Work Order ID 129303

Item Name: Crosstube Turning Detail

DART AEROSPACE LTD		Work Order: 129303
Description: Crosstube Assembly		Part Number: D407-667-245
Inspection Dwg: D407-667-245 Rev: F		Page 1 of 2

DRAWING NO. D407-667-245	TITLE CROSSTUBE ASSY (407 HIGH AFT)	REV. F	DART AEROSPACE LTD ENGINEERING ORDER		D.E.O. NO. D407-667-245-F-1	SHEET NO. SHEET 1 OF 2	SCALE NTS
DRAWN <i>h</i>	CHECKED <i>q</i>	MFG. APPR. <i>h</i>	APPROVED <i>h</i>		DE APPR. <i>h</i>		
DATE 11.04.08	DATE 11.04.12	DATE 11.04.12	DATE 11.04.12		DATE 11.04.12

DRAWING NO. D407-667-245	TITLE CROSSTUBE ASSY (407 HIGH AFT)	REV. F	DART AEROSPACE LTD ENGINEERING ORDER		D.E.O. NO. D407-667-245-F-1	SHEET NO. SHEET 2 OF 2	SCALE NTS
DRAWN	CHECKED	MFG. APPR.	APPROVED		DE APPR.		
DATE 11.04.08	DATE 11.04.11	DATE 11.04.12	DATE 11/04/12		DATE 11.04.12

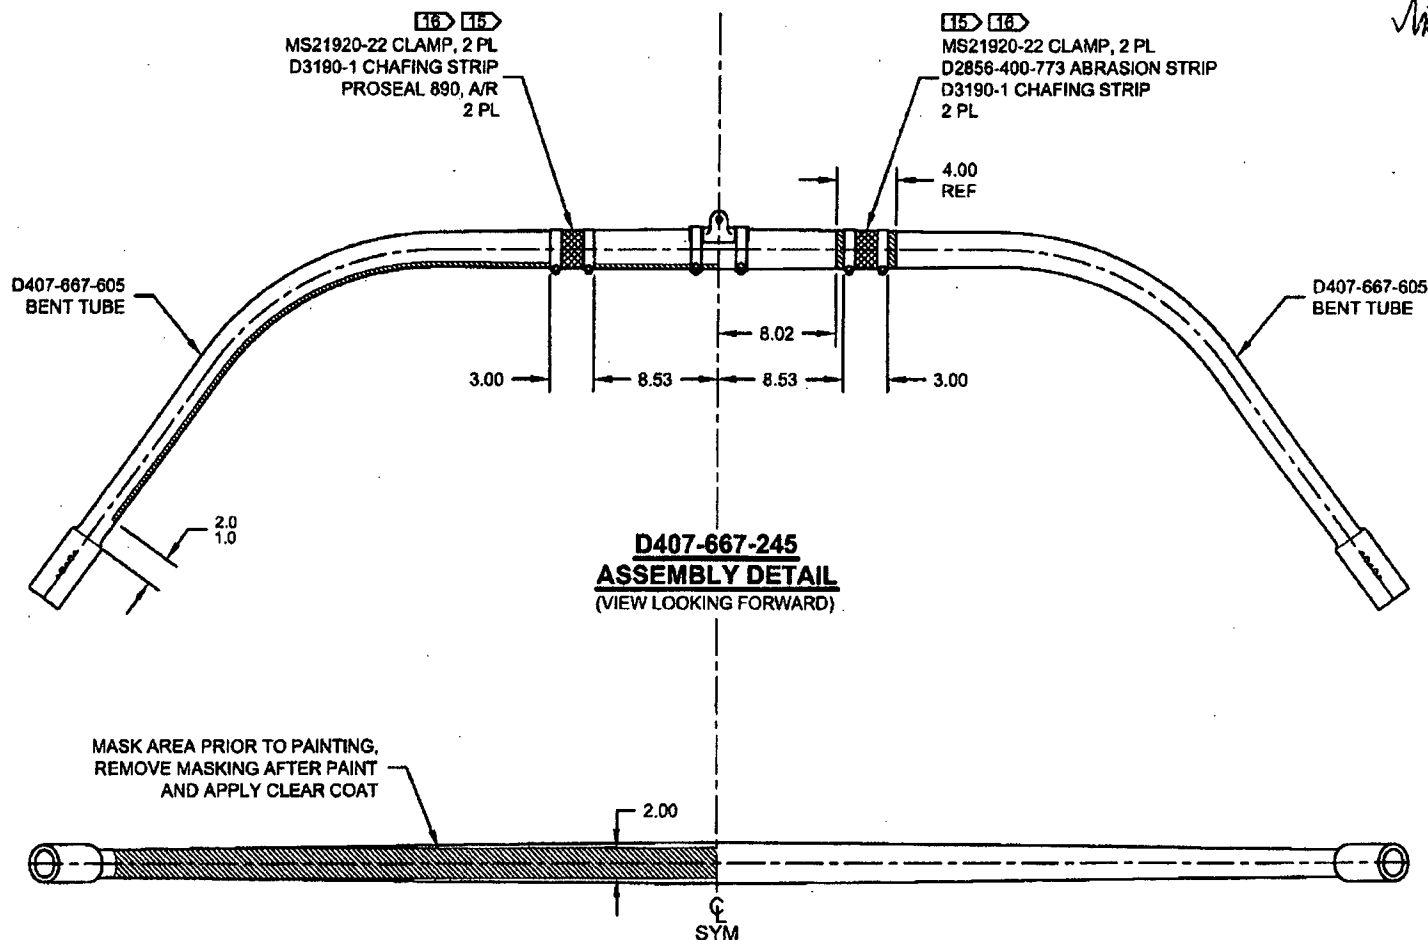
PURPOSE:

REMOVED ABRASION STRIP IN FAVOR OF A THIN LAYER OF PROSEAL 890.

IS:

WAS:
